**ANNUAL CCR LANDFILL INSPECTION
SPURLOCK STATION POWER PLANT**

**EAST KENTUCKY POWER COOPERATIVE
COAL COMBUSTION RESIDUAL RULE COMPLIANCE**

JANUARY 2017

REV. 1 (3/6/2017)

Photograph Number: IMG-7523
Description: CCR outside the north waste limits of Area C, Phase 2

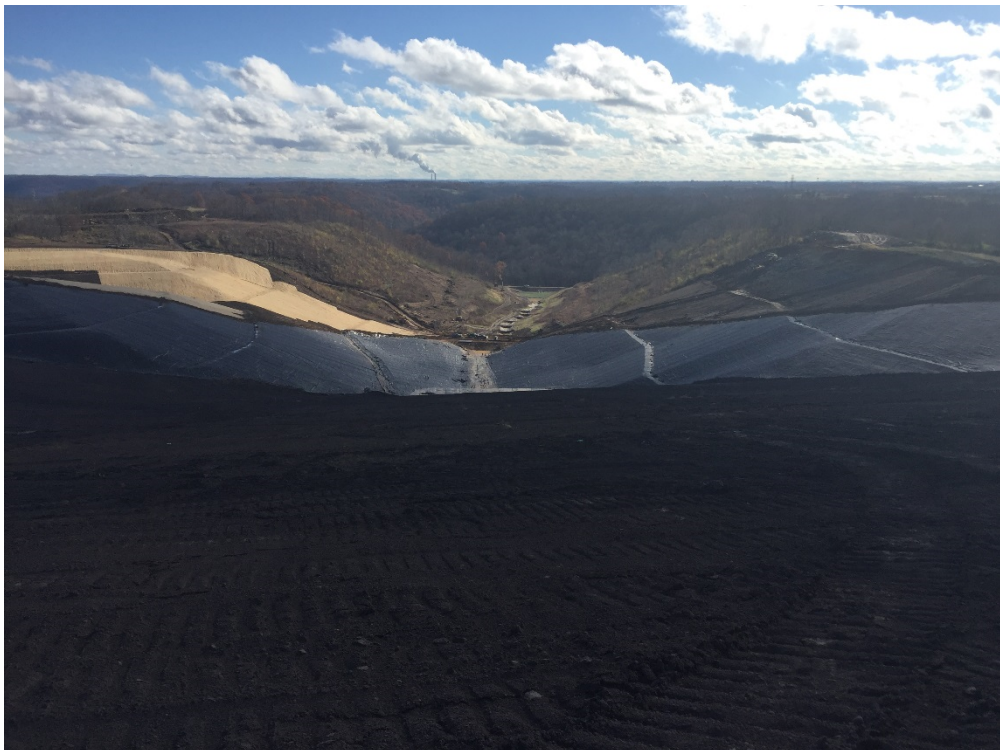
- 4) Minor erosion :
 - Areas of uncovered CCR (Photo IMG-7547),
 - Final cover constructed on the west and south slopes (Photo IMG-7542, 7543).
- 5) Small amount of CCR material outside the northern waste limits at the access point to Area C, Phase 2 (Photo IMG-7523).

- Tall and woody vegetation should be mowed.
- Establish vegetation to deter erosion on final cover.
- For areas that exhibit erosion features including rills or gullies, appropriate measures should be employed to limit erosion.
- Ongoing monitoring of the north slough and future corrective actions for the south slough upslope of Pond 1 and the drainage ditch should be performed to eliminate potential impacts to the ditch, pond and associated structures.
- Monitoring of the landfill for leachate outbreaks and the leachate discharge point for signs of sediment should be done to confirm that the leachate system is not being clogged by the CCR.
